**Re: Initial Submission Review – The Overlook at Sorrell Ranch – Site Plan/Preliminary Plat Comment Responses**

**Application Number:** DA-1379-26  
**Case Number:** 2019-4017-00; 2019-3050-00

# OVERLOOK AT SORREL RANCH SITE PLAN WITH WAIVERS

PROJECT: OVERLOOK AT SORREL RANCH  
 DRAWING: SITE PLAN  
 CLIENT: CITY OF AURORA  
 DESIGNED BY: CW  
 DRAWN BY: CW  
 CHECKED BY: JG  
 HORIZ: 1" = 40'  
 SCALE: VERT: N/A  
 DATE: 08-12-2019

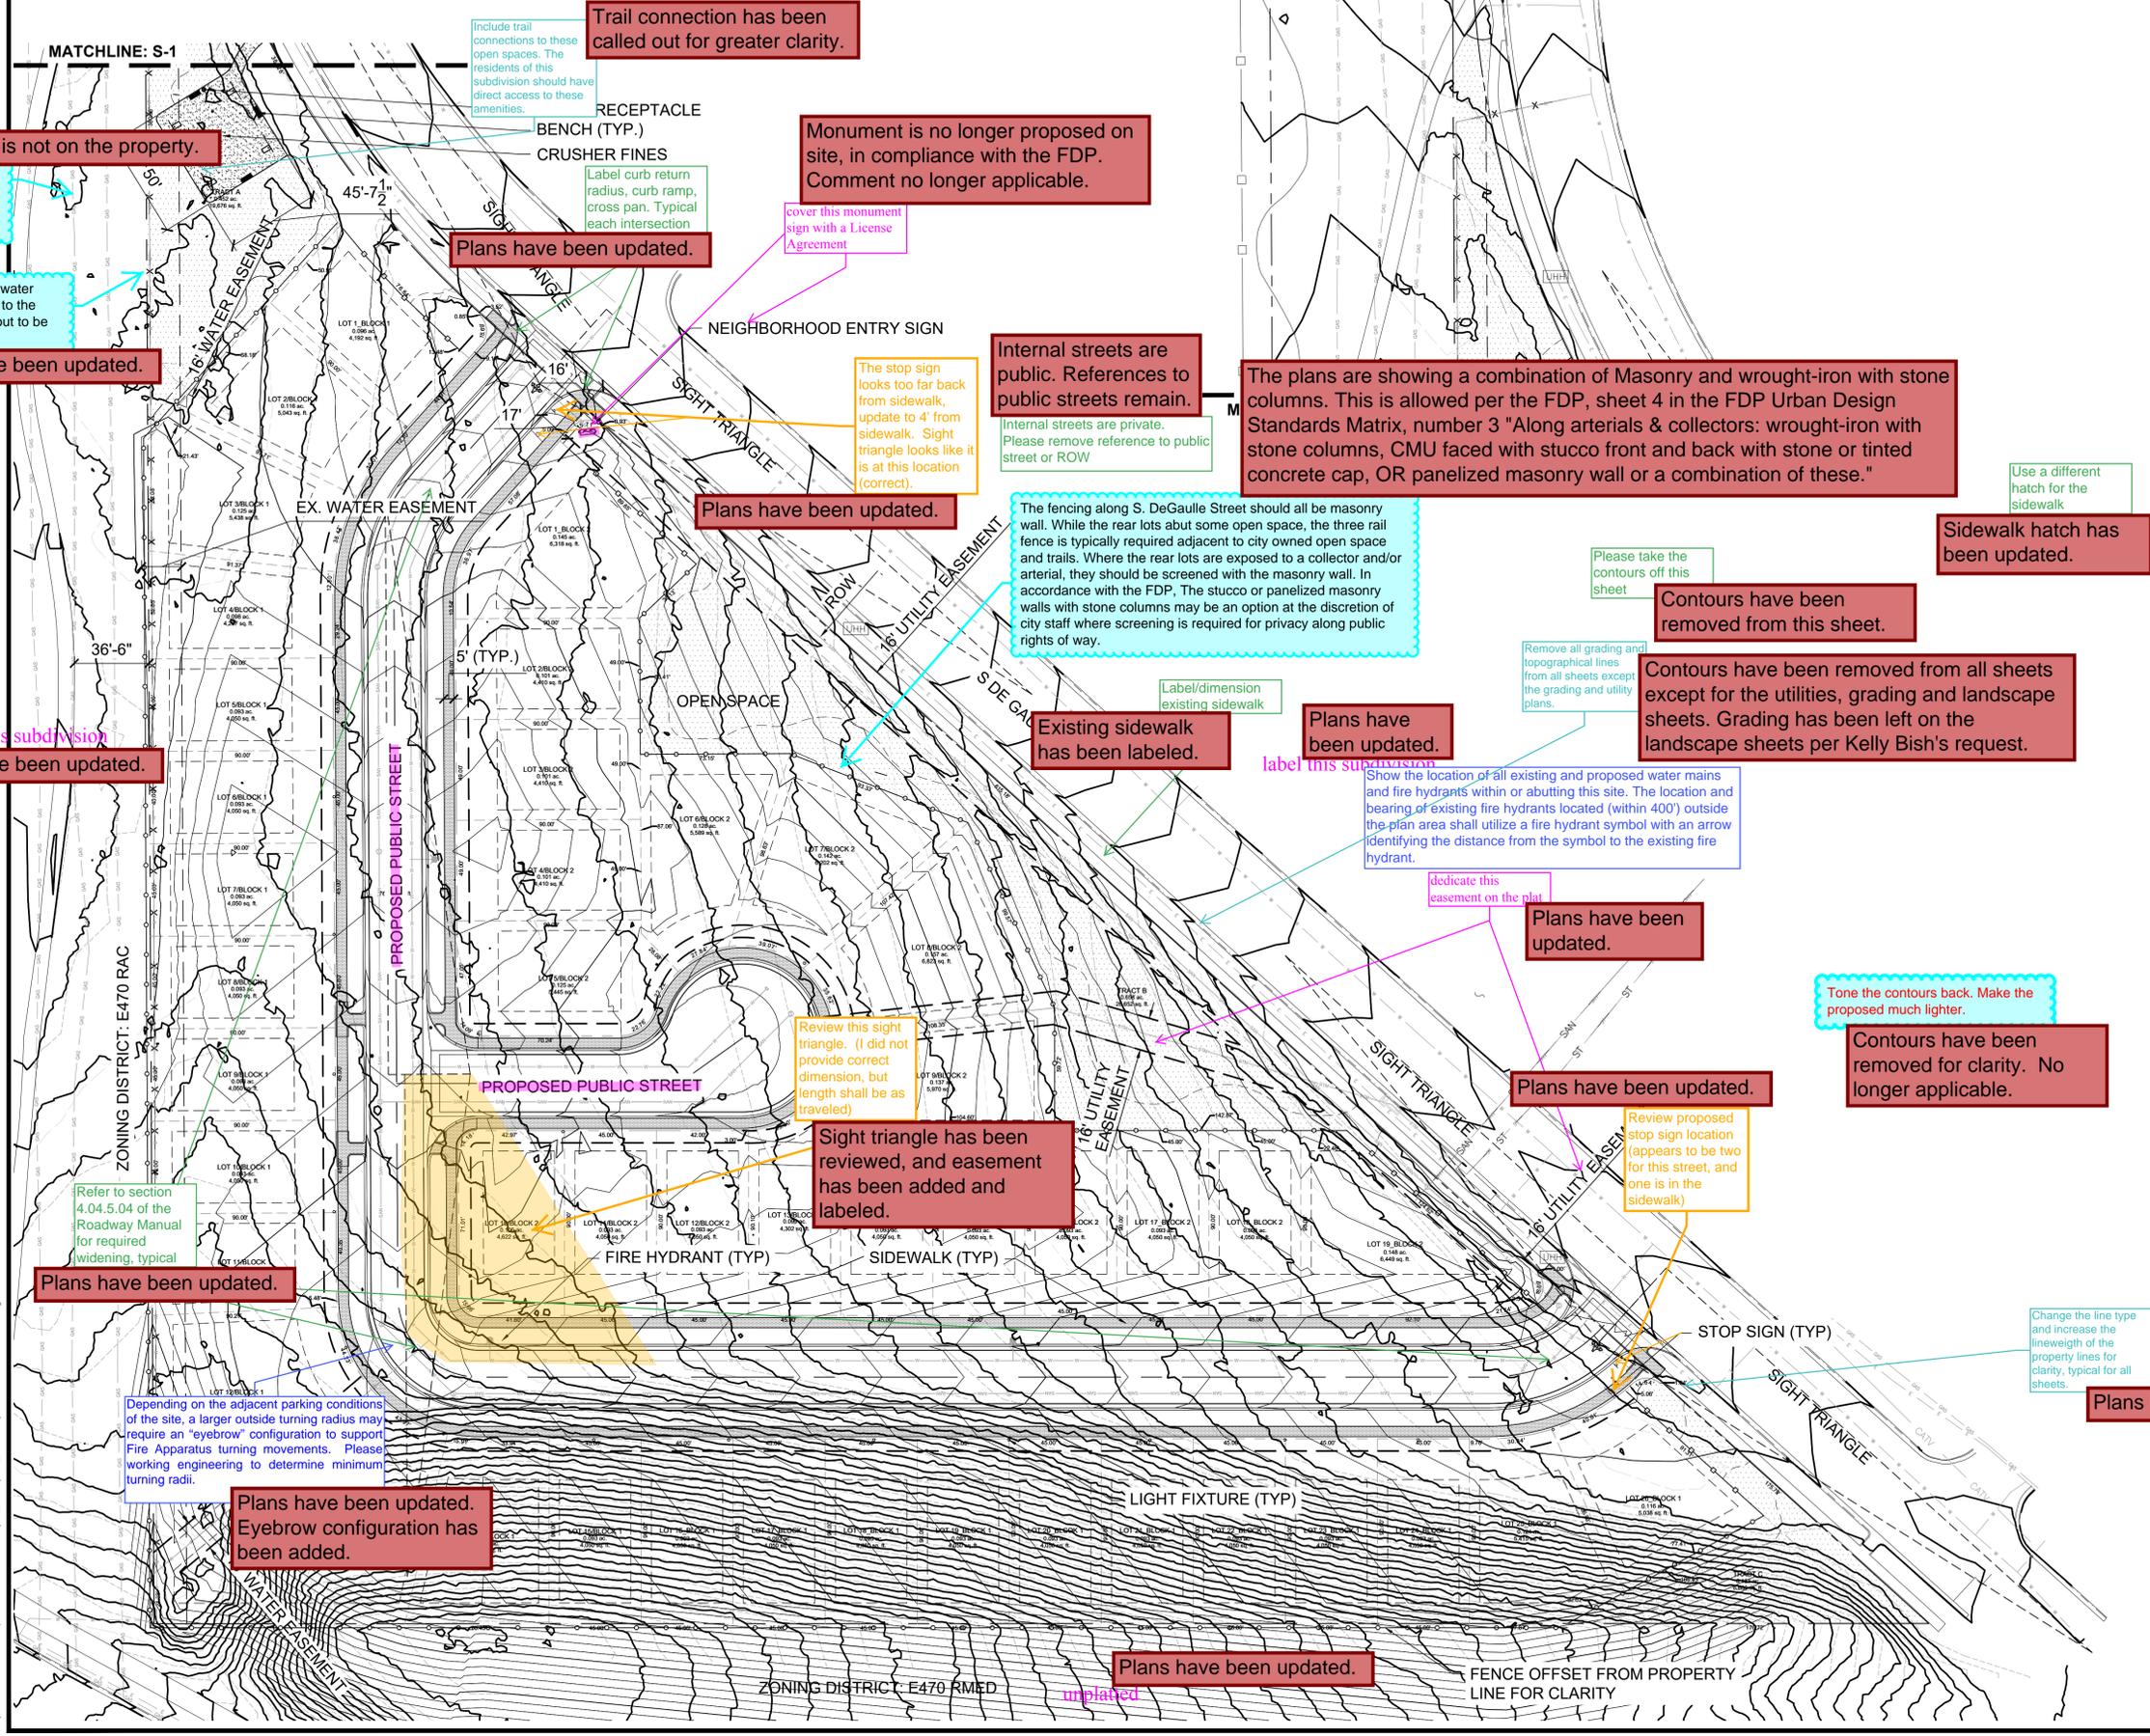
- Dimension and label what appears to be an easement.  
*Easement is off site, see attached easement exhibit. Easement has not been labeled.*
- Add the existing water main symbology to the legend and call out to be abandoned.  
*Plans have been updated.*

- The fencing along S. Degaulle Street should all be masonry wall. While the rear lots abut some open space, the three-rail fence is typically required adjacent to city owned open space and trails. Where the rear lots are exposed to a collector and/or arterial, they should be screened with the masonry wall. In accordance with the FDP, the stucco or panelized masonry walls with stone columns may be an option at the discretion of city staff where screening is required for privacy along public rights of way.  
*The plans are showing a combination of Masonry and wrought-iron with stone columns. This is allowed per the FDP, sheet 4 in the FDP Urban Design Standards Matrix, number 3 "Along arterials & collectors: wrought-iron with stone columns, CMU faced with stucco front and back with stone or tinted concrete cap, OR panelized masonry wall or a combination of these."*

PRIMARY ROAD TYPICAL CROSS SECTION  
N.T.S.

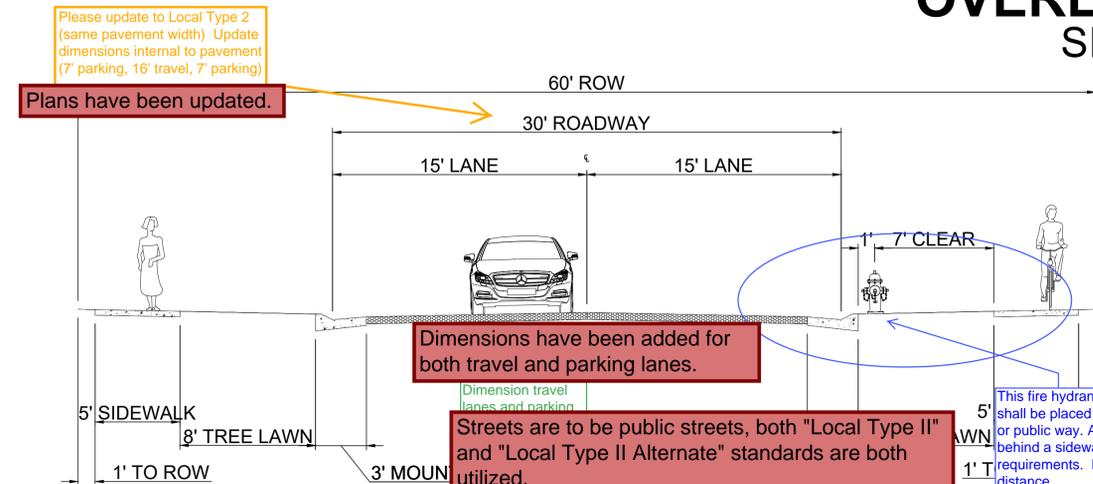
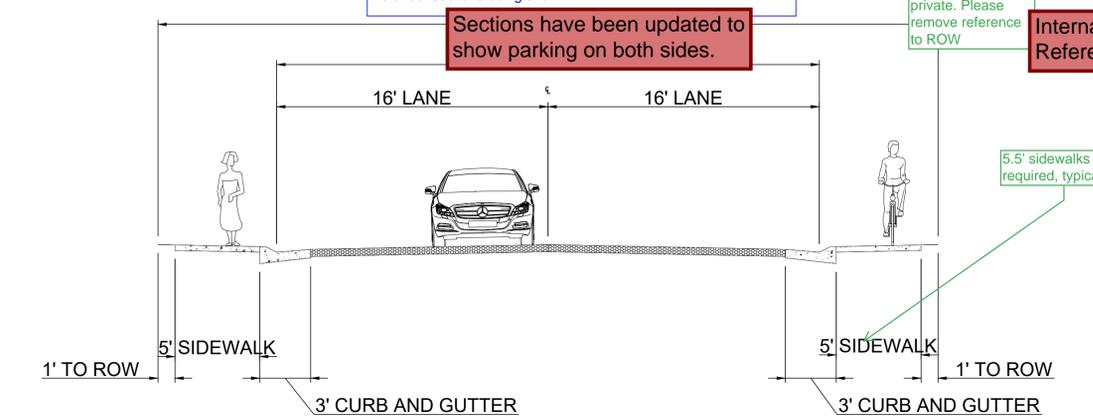
- Dimension the travel lanes and parking in the street sections shown.  
*Dimensions have been added for both travel and parking lanes.*
- The internal streets are private. Please remove all references to ROW.  
*Internal streets are public. References to public streets remain.*
- 5.5-foot sidewalks are required throughout the proposed development.  
*Plans have been updated.*

Internal streets are private. Please remove reference to ROW

Dimensions have been added for both travel and parking lanes.

Sections have been updated to show parking on both sides.

CONCRETE CORNHOLE - ARCO CONCRETE INC.  
N.T.S.

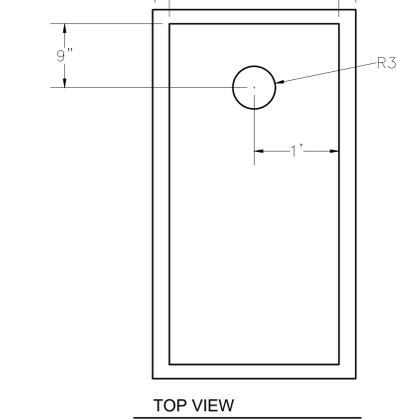
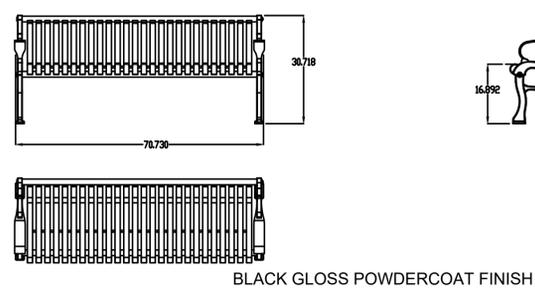
-6C. Remove the cornhole details unless they are permanent.

Are these to be permanent? If not, please remove from this plan sheet.

*Cornhole sets are concrete and are intended to be permanent. Detail remains.*

### WATER CONSERVATION TABLE:

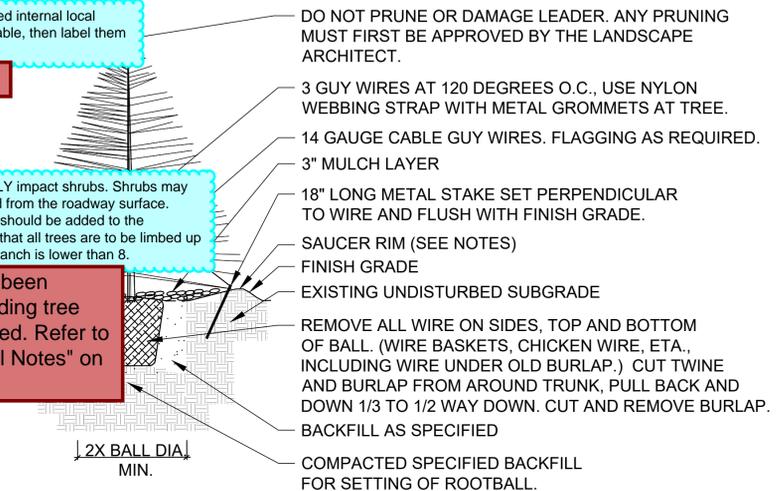
- Update the Standard Right-of-Way Table to include the two-proposed internal local streets.  
*Table has been updated.*
- Update the Water Conservation Table to add a column that represents each landscape category as a percentage of the overall landscape area.  
*Table has been updated.*

Table has been updated.

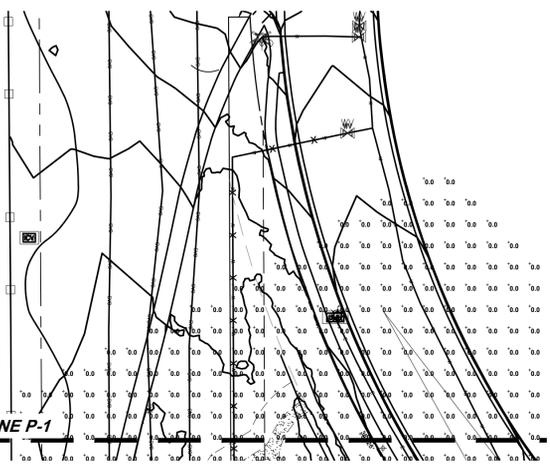
Please remove contours  
Contours have been removed.

SITE LIGHTING  
N.T.S.

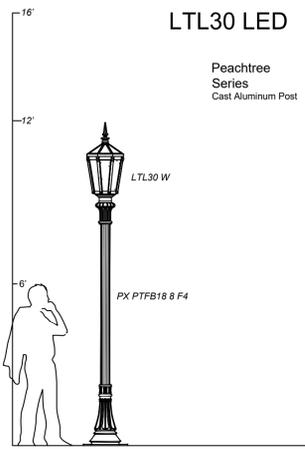
Add a note indicating the on site street lights are private and will be owned and maintained by the HOA or metro district in perpetuity

Street lights are to be public, and maintained by the City of Aurora.
